STATE OF HAWAII
DEPARTMENT OF TRANSPORTATION
HIGHWAYS DIVISION

PANEL LAYOUT

PEARL HARBOR INTERCHANGE
F.A.I. Proj. No. I-HI-(111):14

FRAME LAYOUT

SIGN D-7
R3-14 36" x 30"

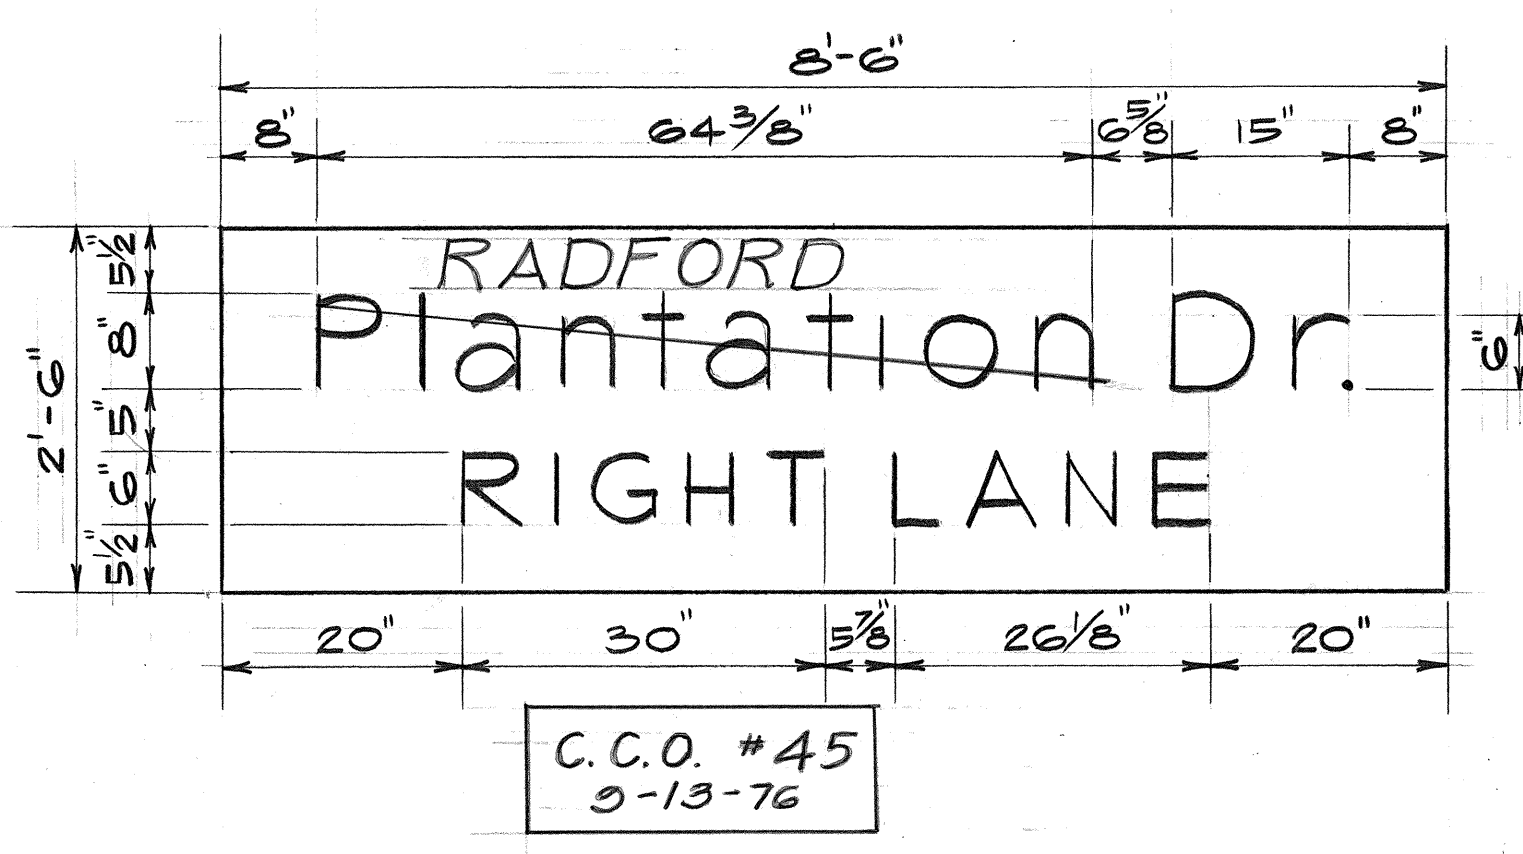
12/17/75	REVISED SIGN PANEL D-7
DATE	REVISION

SIGN E-6
RAMP WN STA. 2+50
FIELD DIRECTIVE June 14, 1976
REFER TO SHTS. C.O. 39R, 42, C.O. 77 & 83

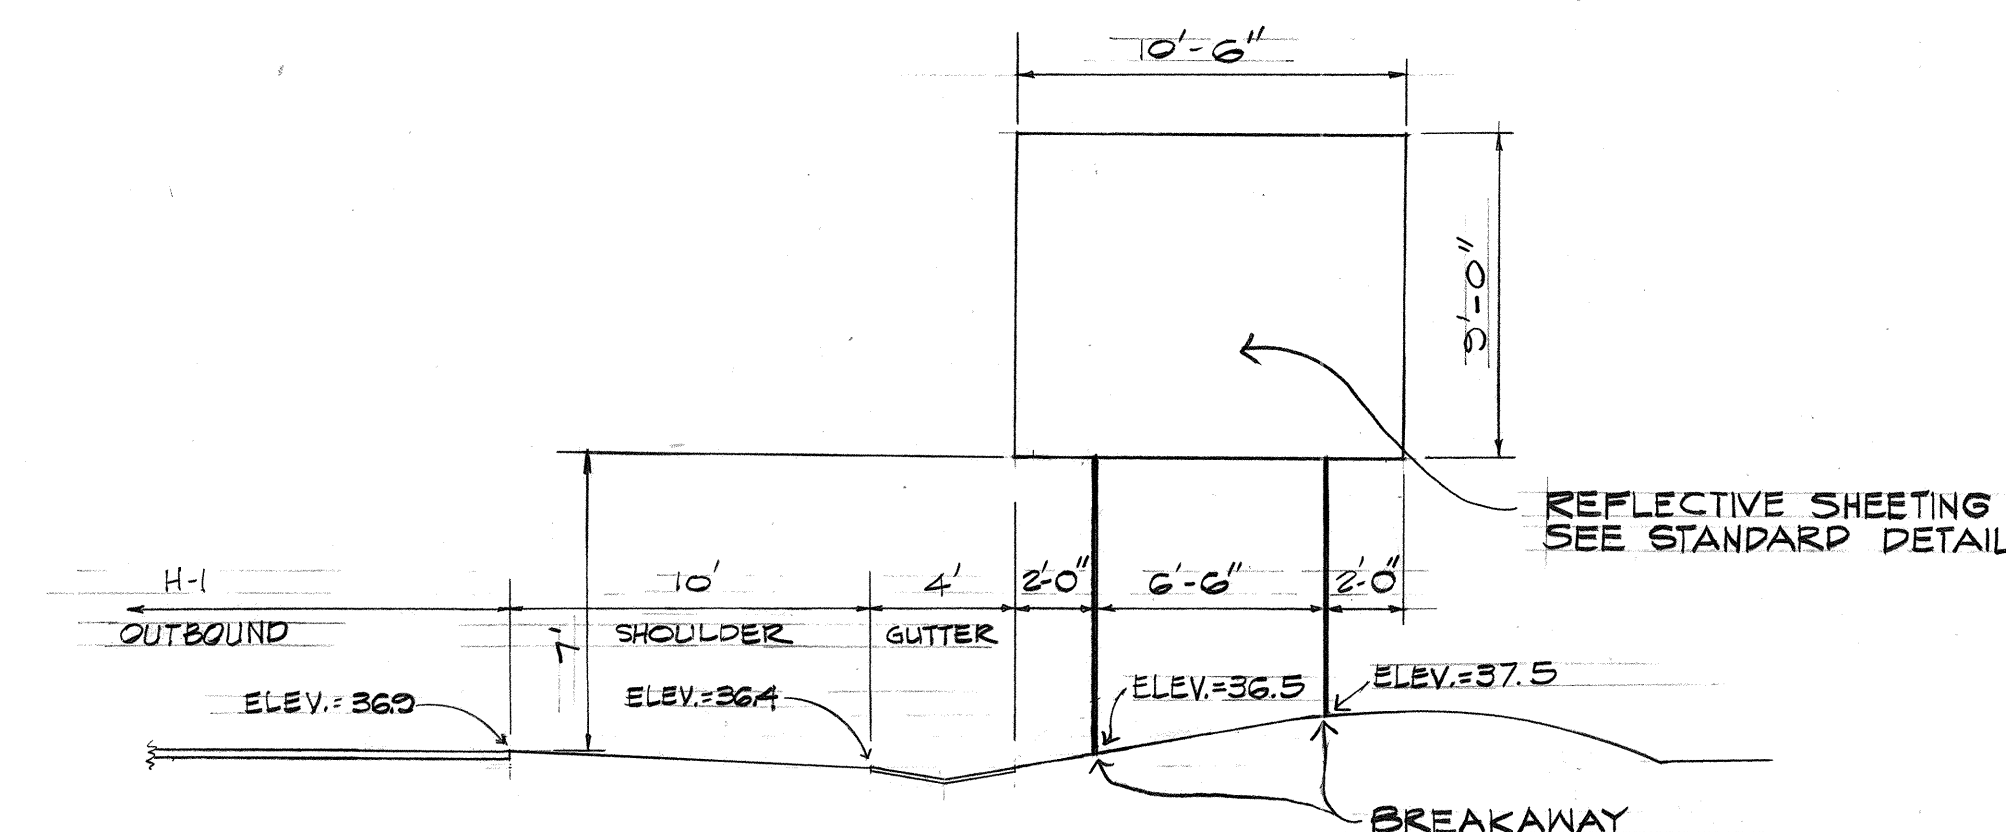
SIGN E-6
RAMP WN STA. 2+50
FIELD DIRECTIVE June 14, 1976
SEE DRAWING ON LEFT (IN RED). FIELD REVISION FOR THE CONFLICT BETWEEN THE 60-INCH CMP DRAINLINE AND SIGN E-6 FOOTING AT RAMP WN STA. 2+50 1/2 RT.
